*Errata***1**

# Manual: 02253

## Manual Index: 0110

Component Side

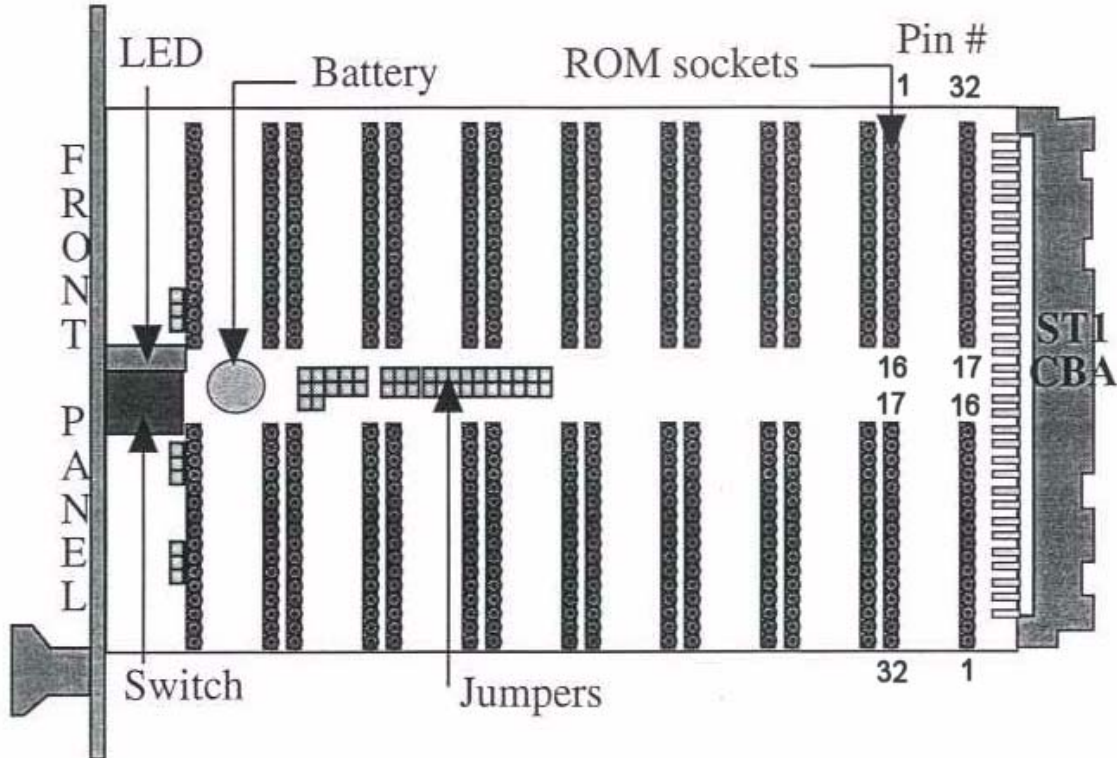
## 1. Reference: Page 1 - 3, Chapter 1.4, Figure

The referenced information (figure indicating Board Overview – Component Side) is superseded by the following figure.
